Product/Process Change Notice (PCN)

PCN_WS-TST/TSW

WS-TST 6*6mm, WS-TSW 12*12mm

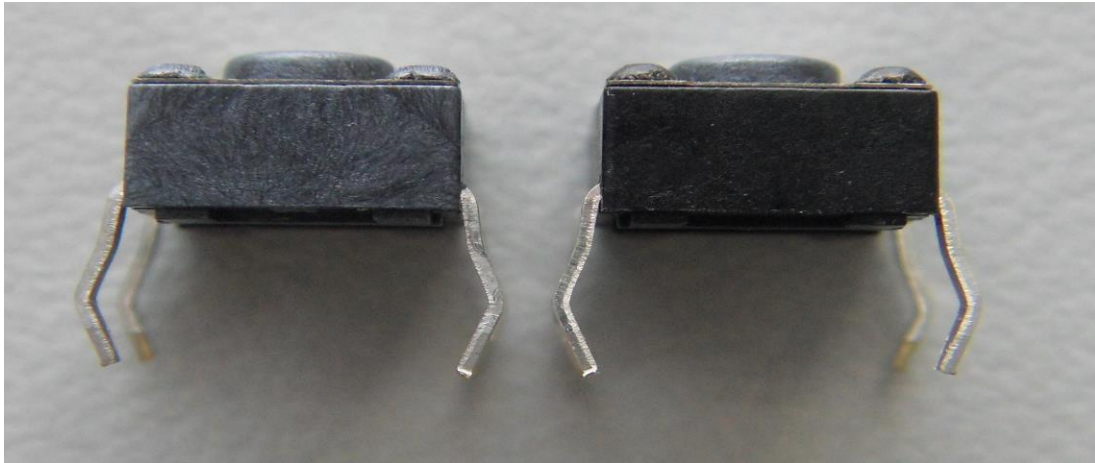
For improving the product reliability Würth Elektronik changes the plastic material and the plating.

The new product housing is made from the high temperature resistant polymer material PA9T. The appearance of the housing is black. Instead of Tin we use Silver for the product plating to enhance wettability.

The change does not influence Fit, Form and Function.
